**Proposed Vehicle X-Over Fronting onto a Classified Road. 5 Forge Lane,
Higham. ME3 7AS. Pursuant to Refusal Ref 20250570.**

Further to our letter dated the 3rd of June 2025, we are now submitting an amendment to drawing 209 following a response from KCC plus clarifying certain aspects of the current submission.

Amended Crossover Drawing 209A

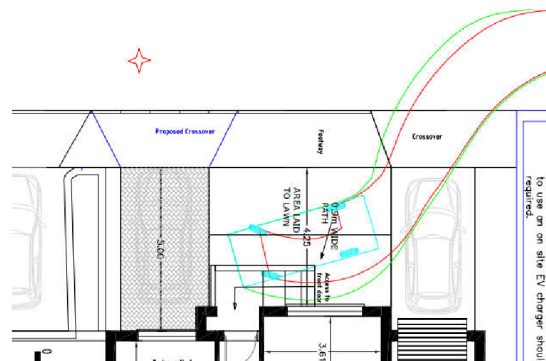
KCC have queried the distance between crossovers. There is a simple answer. Drawing TAB/06/85A shows the current crossovers. It does not show the proposed crossover.

There appears to be a discrepancy between drawing TAB/06/85A and TAB06/209 with the former showing approximately 10m between the two crossovers and the latter showing approximately 4m. Clarification is required. Please note, planning permission does not convey

Drawing No TAB/06/209 (amended to 209A) shows the proposed crossover plus access. KCC have also stated:-

crossover team. It is unlikely that the vehicle crossover team would approve this application if the required 4.5m minimum width of raised kerbs between the two crossovers cannot be achieved. This is because you would be unable to park a vehicle between the two crossovers, further reducing on street provision, in a street that is heavily parked.

We provided a vehicle tracking drawing TAB/06/208A to prove the reason behind having a new access as the front garden area is too small to manoeuvre into and park. The path and steps to the front door also cut into the area. An extract from the tracking is shown below.

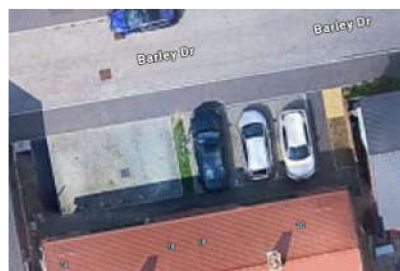
We have shown on Drawing TAB/06/209A two sight lines. One is 2mx2m, on the northern side. The southern sight line is 1m x 1m, however the client is agreeable to reduce a 2m length to 0.6m.

An extract from the Kent Design Guide is also included on the drawing. The parameter range is between 1m and 2m. When visiting site and reviewing crossovers along Forge Lane most if not all have no 2m x 2m in place. This is especially true where accesses are on the common boundary. New developments such as in Barley Drive that have parking provision as shown below do not have 2m x 2m sight lines.

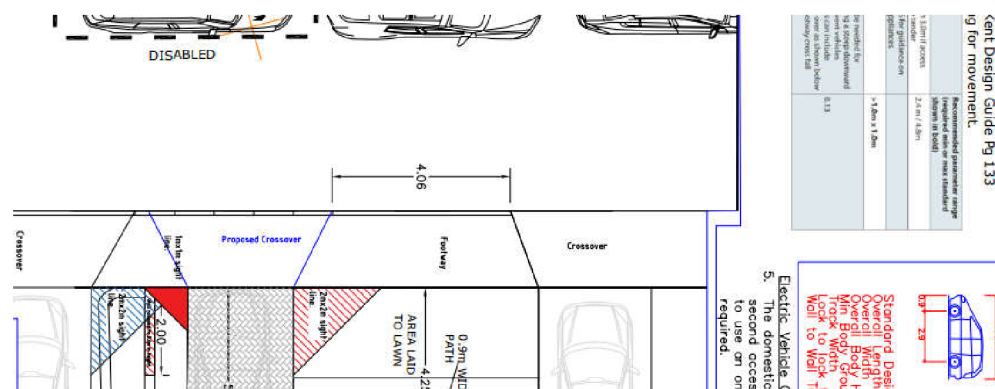
An extract from 209A is shown below. It shows the neighbours sight line is not fully in control.

Based on the above review of KCC's comments, which are considered a positive response, the amendments to drawing 209A fully encapsulates their recommendations.
